STATEMENT OF ENVIRONMENTAL EFFECTS

**PROPOSED DEMOLITION OF EXISTING STRUCTURES
AND REMOVAL OF EXISTING TREES. PROPOSED BATTLE
AXE SUBDIVISION INTO 2 LOTS AND CONSTRUCTION OF
A TWO STOREY DWELLING AT THE FRONT AND REAR
LOT (S4.55 Amendment)**

**@ 8 Hillview Avenue, Bankstown
NSW 2200**

7.4. S4.55 Statement & Amendments Request

Below is a few images of the changes clouded on the plan.

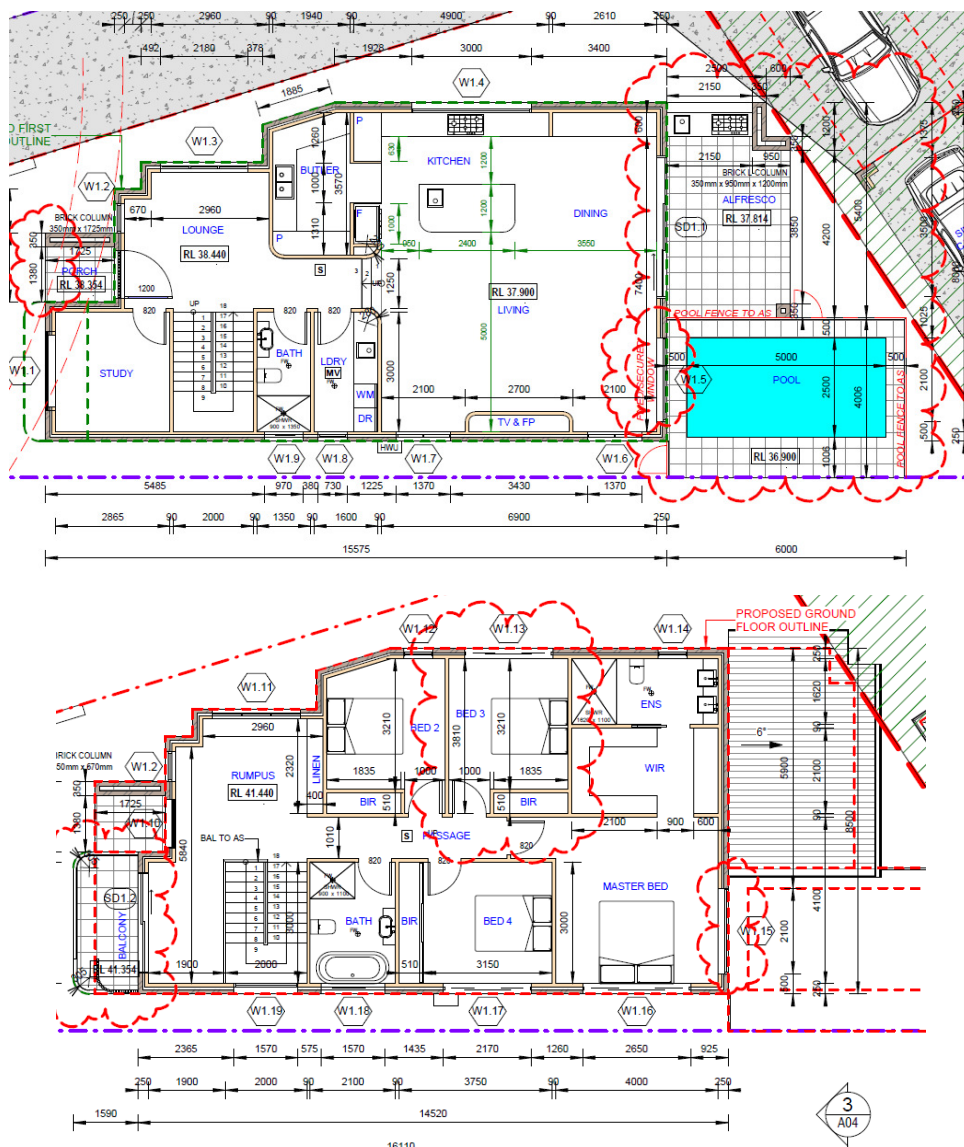
FRONT DWELLING

- Porch change to Front dwelling
- Alfresco layout reconfigured
- Inground pool added in outside of electrical easement adjacent to alfresco
- Small internal layout changes made to laundry and butler kitchen
- First floor redesigned to allow for a 4th bedroom
- 4 window changes as per new layout
- Façade redesigned as per 3d render
